DEFENSE NUCLEAR FACILITIES SAFETY BOARD

Staff Issue Report

SUBJECT: Review of Plutonium Stabilization and Packaging System

This memorandum documents an issue associated with the Plutonium Stabilization and Packaging System (PuSPS). This issue was reviewed by members of the staff of the Defense Nuclear Facilities Safety Board (Board) D. Grover and M. Sautman on June 16–17, 1999, at the Rocky Flats Environmental Technology Site (RFETS).

Figure 1. DOE-STD-3013 Inner Container and Glovebox Port Configuration

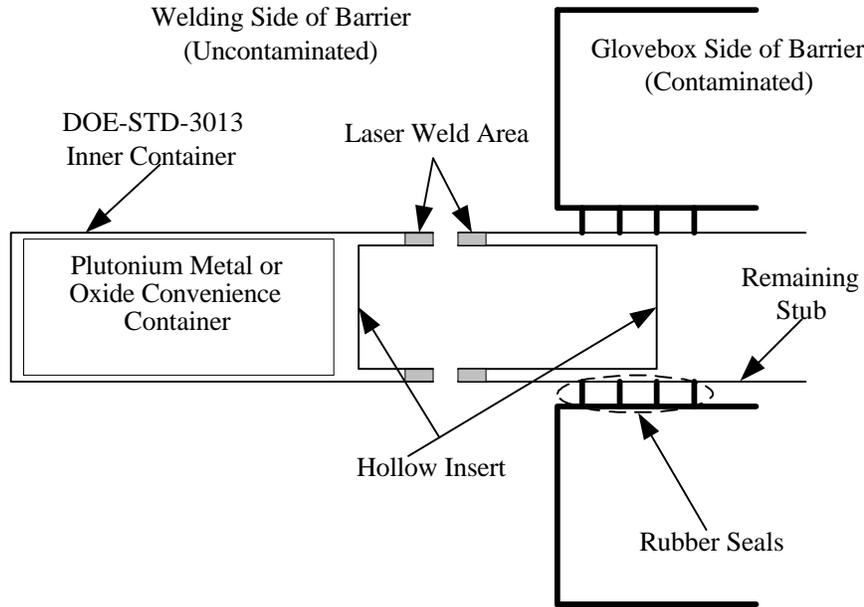
Contamination on Inner Container. Per DOE-STD-3013, *Criteria for Preparing and Packaging Plutonium Metals and Oxides for Long-Term Storage*, the outer surface of the inner container of a plutonium package is required to be free of removable surface contamination in excess of the limits specified in 10 CFR 835. In the RFETS PuSPS, the inner can is partially inserted into the side of the glovebox through a series of rubber rings that forms a contamination seal around the can. Plutonium metal or oxide is then inserted into the can, followed by a hollow insert that forms an interference fit in the opening of the inner container. A laser is then used to weld the inner can to the hollow insert. Finally, a laser cuts through the can and hollow insert in the welded area. One side of the hollow insert forms the lid of the now sealed, contamination-free container; the other side remains attached to the upper remnant of the inner can, forming a plug that seals the glovebox port (see Figure 1). RFETS has identified the potential for plutonium oxide present between the container and hollow insert to become trapped in the weld and subsequently vaporized during the laser cutting operation. This material could deposit on the container and result in transferable radiological contamination exceeding that allowed by the storage standard.

The staff considers the planned process improvements appropriate to minimize the probability of contaminating an inner container. However, the PuSPS does not have a method for checking the inner container for contamination to determine whether the container meets the storage standard or identify the extent of any contamination. The PuSPS also lacks the capability to remove any contamination. Additional design changes to incorporate the ability to check inner containers routinely for contamination would be appropriate, allowing verification that the requirements of the standard are being met. In addition, an adjacent work area for removal of contamination above the limits of the standard would be useful to minimize the number of containers not meeting the requirements of the standard.

To deal with this deficiency, RFETS has initiated procedural and design changes to minimize the extent of the contamination on the containers. Daily housekeeping of the gloveboxes will be performed to minimize the quantity of oxide available to contaminate the container. In addition, a fume hood will be added next to the welding and cutting area to draw contamination away from the outer surface of the inner container during cutting. Finally, a confinement barrier will be placed around the weld equipment housing to prevent contamination from being released into the general work area. However, these proposed changes may not prevent the accumulation and migration of contamination along the process path, with eventual release outside of the planned confinement area. RFETS has also initiated an effort to revise the
